Staff Report

From: Dan Handel, AICP, Planner

Meeting Date: January 11, 2024 (Prepared January 4, 2024)

Item: DR 23-09, SA 23-07, & VAR 23-07 "Salud Medical Center Renovation" at 1175 Mt Hood Avenue

Figure 3.01B – Major Arterial

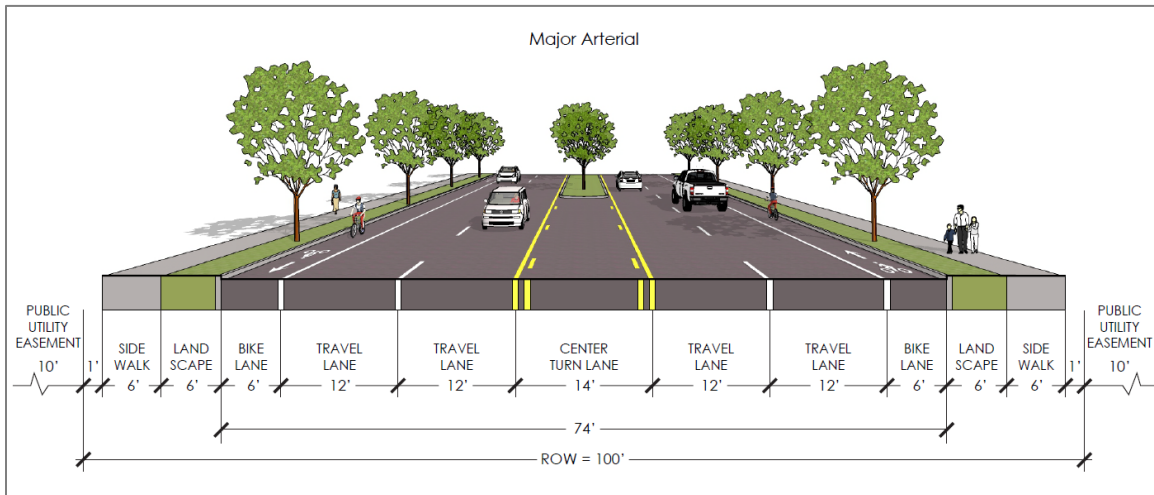
The proposal is commercial development therefore the standards within 3.01 do apply. The subject property has frontage along Mt Hood Avenue, which TSP Figure 2 illustrates is a major arterial street. The default cross-section for major arterial streets is Figure 3.01B. Existing conditions of Mt Hood Avenue along the property include:

■ The applicant submitted a Street Adjustment request to not widen the street to provide two westbound travel lanes in addition to the center turn lane, and to maintain the curbtight sidewalk with landscape strip behind it. This request is analyzed and discussed further under the Street Adjustment provisions.

City records do not indicate an existing streetside public utility easement. Figure 3.01B notes a 10-foot streetside public utility easement along major arterial streets therefore staff adds *Condition of Approval 7b* to grant this easement.

- b. Streetside PUE: To meet 3.02.01B and Figure 3.01B, grant a 10-foot-wide public utility easement along the frontage of Mt Hood Avenue.
8. Street lighting: Pursuant to 3.02.03A, adjacent street lighting for Mt Hood Avenue shall comply with City of Woodburn and Portland General Electric (PGE) standards and specifications. The applicant shall either provide documentation to the attention of the

SITE PLAN

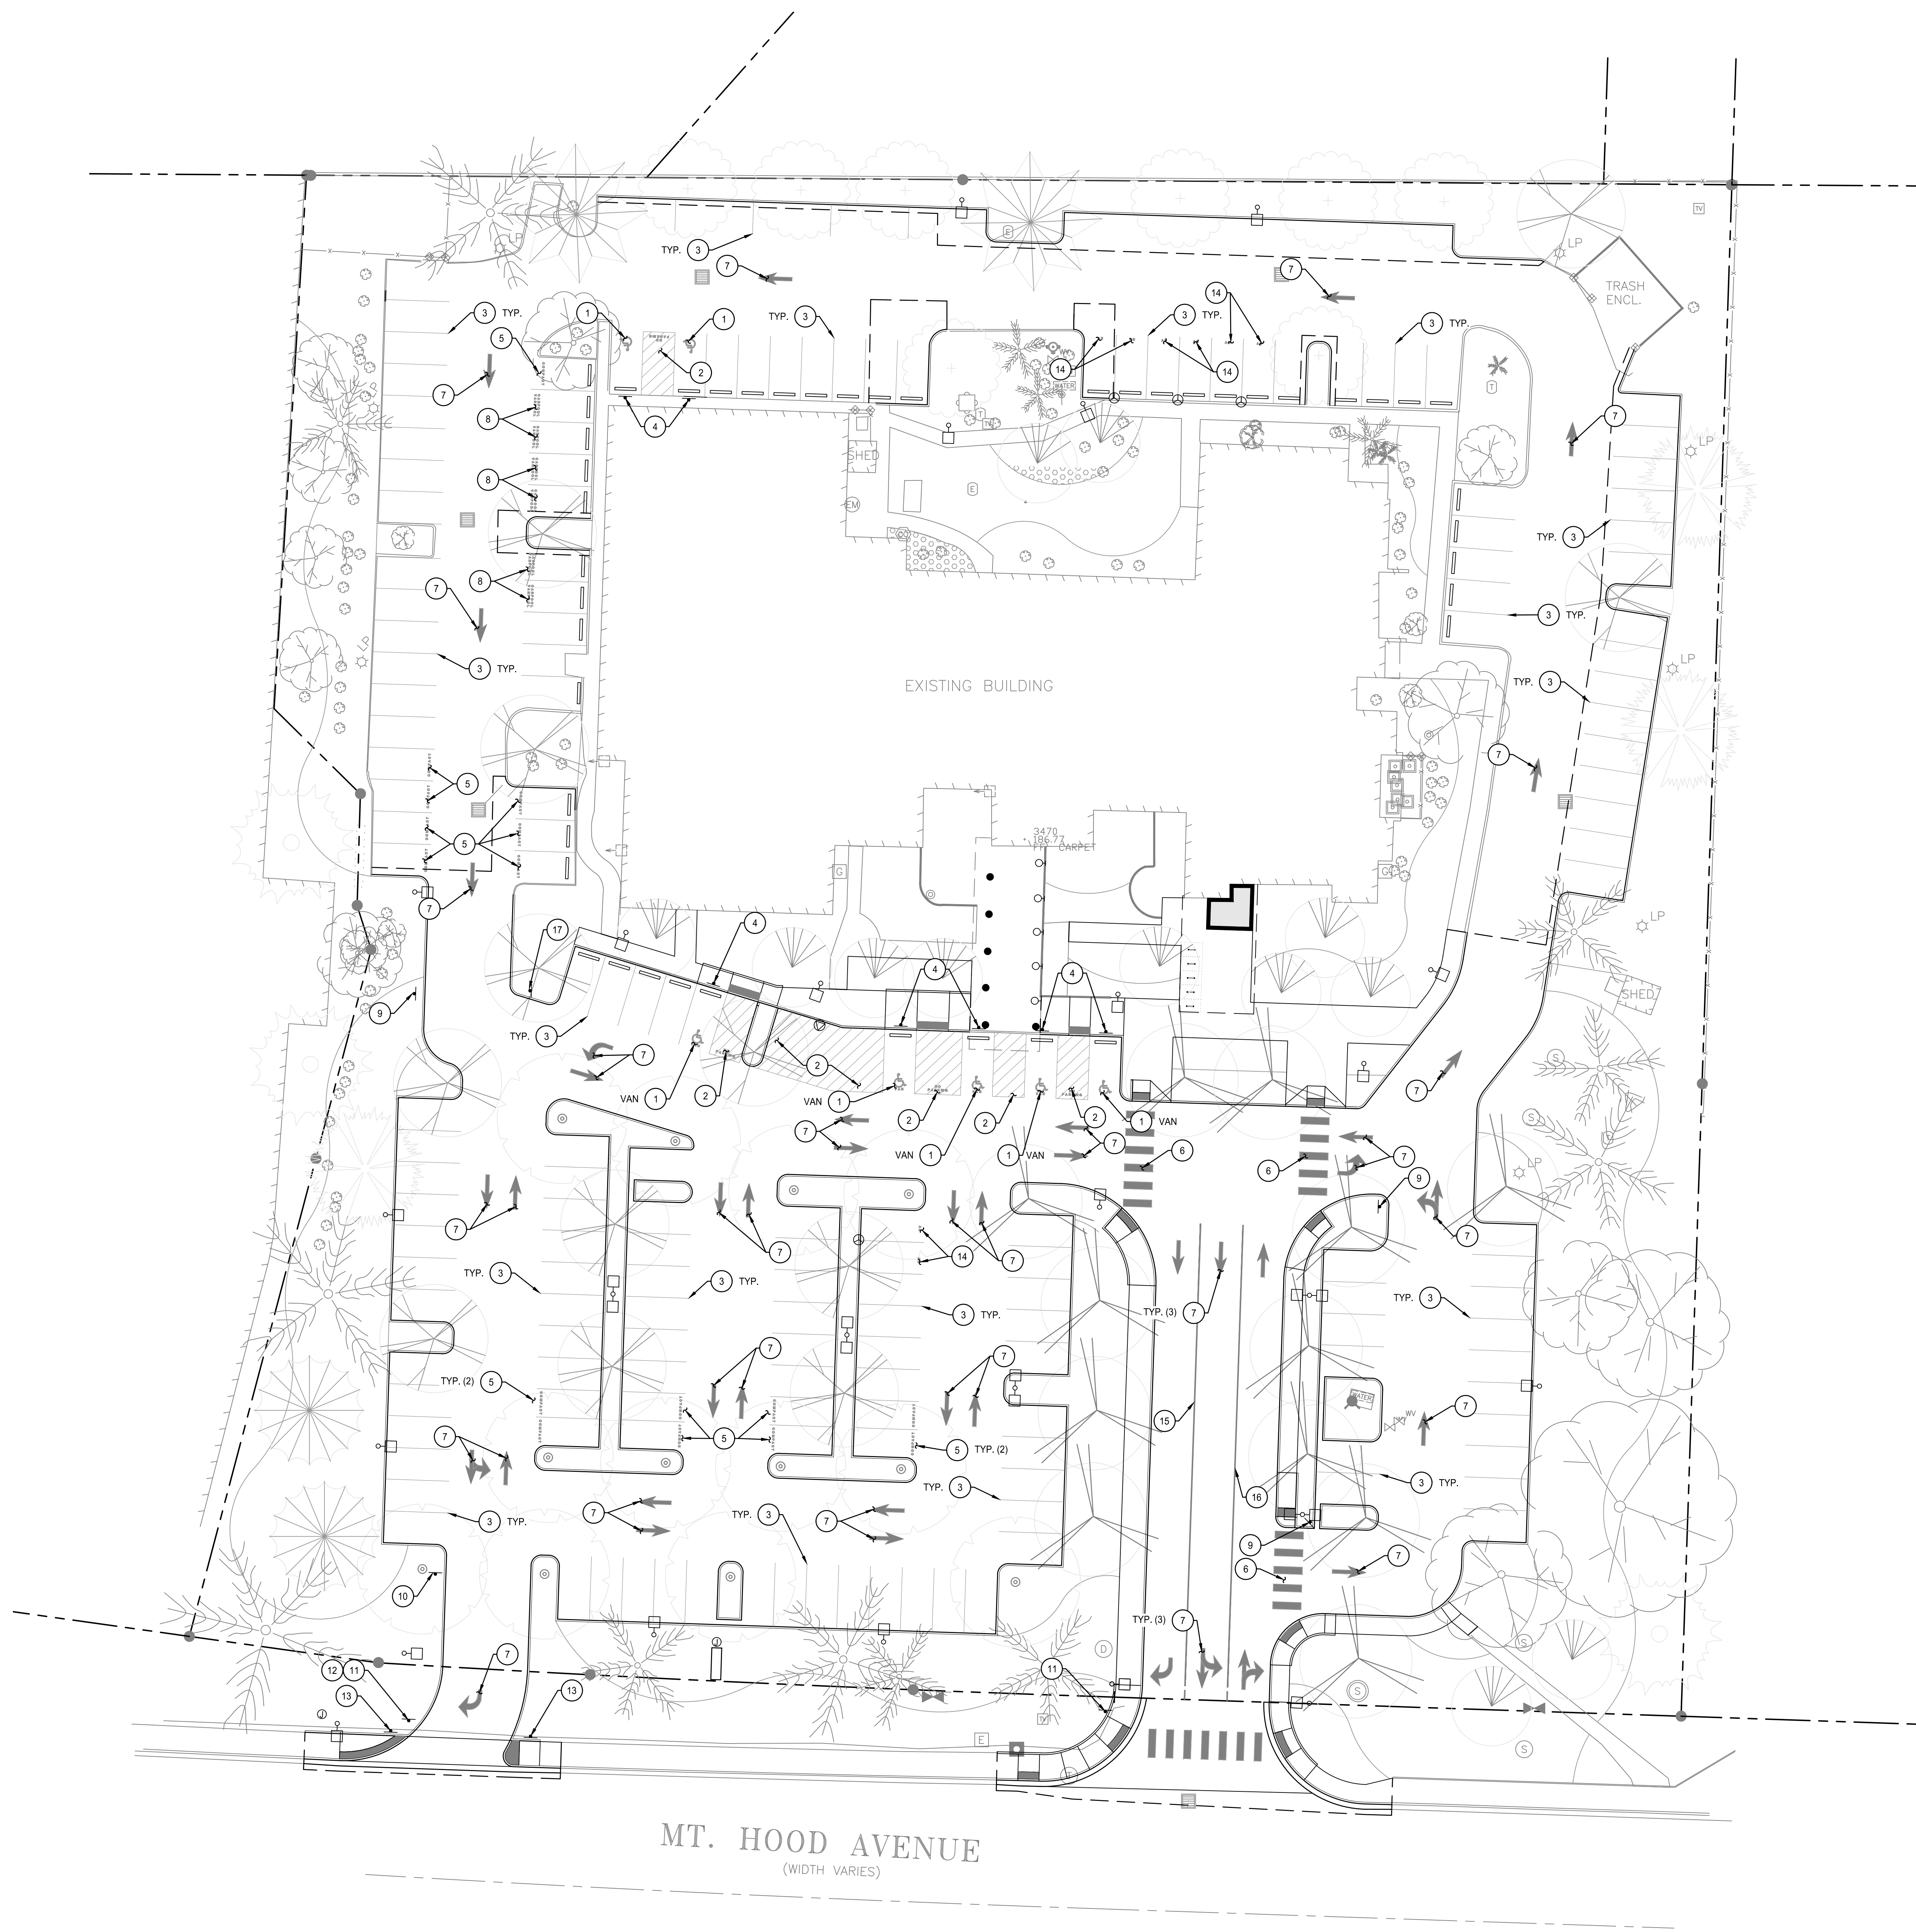
The subject property has an existing driveway aligned with Park Avenue. Site plans illustrate and note this driveway is 36 feet wide, serves two-way traffic, and includes a left turn pocket.

Plans also illustrate a proposed second driveway accessing Mt Hood Avenue, which appears to be 24 feet wide and would function as a right-out-only driveway. Because the subject property already has a primary driveway that serves two-way traffic, the subject property fronts a major arterial street, and the proposed second driveway is for one-way traffic leaving the site, staff adds *Condition of Approval 10b & c* to limit the width of the proposed right-out-only driveway to be no more than 12 feet wide at the property line and also require a traffic control sign instructing drivers along the highway that this is an exit only.

The subject property has one frontage along Mt Hood Avenue. Site plans illustrate two wide walkways along the main driveway connecting the building entrance to sidewalk within the right-of-way. Site plans do not illustrate either of these wide walkways meeting the drive aisle crossing requirement for visual distinction therefore staff adds *Condition of Approval 11* to meet this requirement.

As analyzed for 3.05.03A, the minimum parking requirement is 122 stalls and the site plan illustrates 168 stalls provided therefore the minimum C/V parking requirement is 5 stalls. The site plan illustrates 6 C/V stalls provided along the building perimeter walkway. Staff adds *Condition of Approval 12c* to meet the striping and signage requirements.

As analyzed for 3.05.03A, the minimum parking requirement is 122 stalls and the site plan illustrates 168 stall provided therefore the minimum EV parking requirement is 8 stalls. The site plan illustrates 8 EV stalls provided that meet the location requirement. Staff adds *Condition of Approval 12d* to meet the charging level, striping, and signage requirements.

As analyzed for 3.05.03A, the minimum parking requirement is 122 stalls and the site plan illustrates 168 stall provided therefore the minimum bicycle parking requirement is 25 stalls. The site plan illustrates 25 bicycle parking stalls provided, 13 of which will be sheltered. All stalls meet the location requirement. Staff adds *Condition of Approval 12e* to meet the facility and dimension requirements.

- c. The maximum width of this driveway shall not exceed 12 feet at the property line.
11. On-site crosswalks: To meet 3.04.06D, the wide walkway crossings over the drive aisle shall be made visually distinct from the asphalt pavement by either using stamped concrete or constructing a raised walkway crossing. Revise site plans to demonstrate conformance as part of the building permit application.

12. Parking: The developer shall revise plans as needed to provide the following:
 - a. All existing and proposed parking stalls shall be delineated with double parallel line striping to meet 3.05.02K and Figure 3.05C.

- b. Pursuant to 3.05.03B, accessible parking shall be provided to meet applicable state statute and building code requirements.
 - c. Pursuant to Table 3.05C, the developer shall provide at least 5 carpool/vanpool parking stalls that meet the striping and signage requirements in 3.05.03H.

- d. Pursuant to Table 3.05E, the developer shall provide at least 8 electric vehicle parking stalls that meet the charging level, striping, and signage requirements in 3.05.03I.

- e. Pursuant to 3.05.03E and Table 3.05D, the developer shall provide at least 25 bicycle parking stalls that meet the facility and dimension standards in 3.05.06 and Table 3.05G.
